**Federal Highway  
Administration**

Refer to: HMHS-B60

In your October 22 letter, you requested Federal Highway Administration (FHWA) acceptance of a modified w-beam rail element called O-Rail for use with strong-post w-beam guardrail on the National Highway System (NHS). To support this request you included copies of a Southwest Research Institute report dated October 1999 written by Mr. Joe B. Mayer, Jr. and entitled "FULL-SCALE CRASH EVALUATION OF A G4-1S TYPE GUARDRAIL SYSTEM USING THE O-RAIL ELEMENT AS THE RAIL SECTION," and copies of a videotape showing the test that was run.

**Figure 1. Comparison of O-Rail Section to Standard W-Beam Section, Test O-R 102**

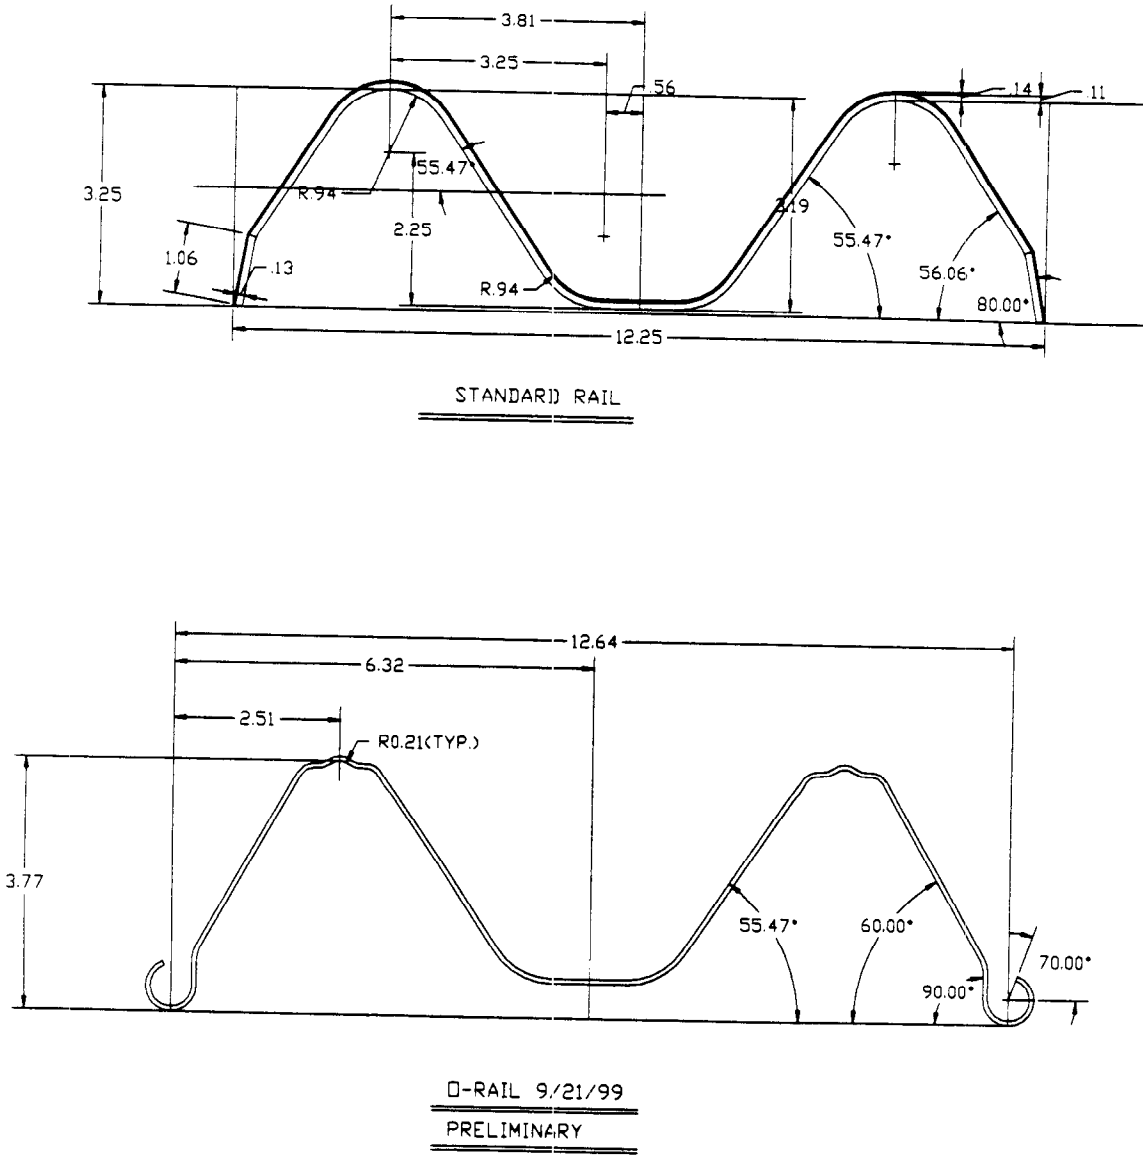
We note that the O-Rail is shaped similar to a standard w-beam rail element, but uses flutes and edge curls "to redistribute material to critical stress locations". The tested design was fabricated from 15-gauge galvanized steel. The curled edges are crushed flat on one end of each beam so they will slide into the curl of the adjacent downstream beam at the spliced joint to minimize vertical flexure at the joint. The O-Rail dimensions are such that it can be spliced to standard w-beam rail elements with the w-beam either on top or underneath the O-Rail at the splice location. However, the O-Rail itself cannot be nested. Enclosure 1 shows a comparison the O-Rail cross section geometry to the standard w-beam section.

Based on our review of the information you submitted, we conclude that the O-Rail may be used on the National Highway System as a direct substitute or replacement for standard w-beam on strong post systems when such use is requested by a transportation agency. Since you ran your test with the more-critical steel posts and 150-mm deep wood blockouts, our acceptance also includes its use with standard wood posts and with either 150-mm or 200-mm (6-inch or 8-inch) deep routed wood or recycled plastic blocks. Standard w-beam rail elements must continue to be used with all proprietary w-beam terminals and in all guardrail-to-bridge rail transitions unless they are re-tested using O-Rail.

Figure 4. Summary of Results, Test O-R 102

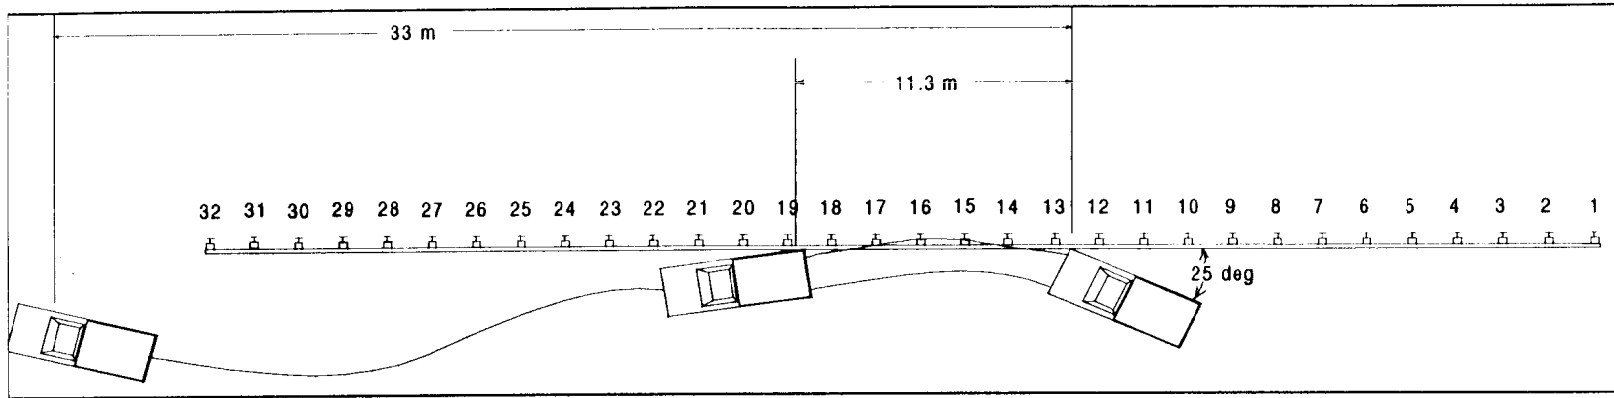
You ran NCHRP Report 350 test 3-11, a 25 degree impact with a 2000-kg pickup truck at 100 km/h, into a standard strong-post system with W150 x 13.5 (W6 x 8.5) posts and 150 mm x 150 mm x 350 mm (6 inch x 6 inch x 14 inch) routed wood blockouts. In lieu of standard w-beam, 3800-mm long sections of O-Rail were used. Enclosure 2 is a copy of the summary test results. We note that the permanent deflection of the O-Rail (1168 mm or approximately 48 inches) was slightly greater than comparable tests with standard strong post w-beam systems, but that the occupant impact velocities and maximum roll angle of the pickup truck were substantially lower than they were in tests with wood and steel post designs with standard 200-mm (8-inch) deep blockouts and with 150-mm (6-inch) deep blockouts.

We are willing to waive test 3-10 based on the results of your test 3-11 and on other tests that have been run on standard w-beam guardrail with the 820-kg car at 20 degrees.
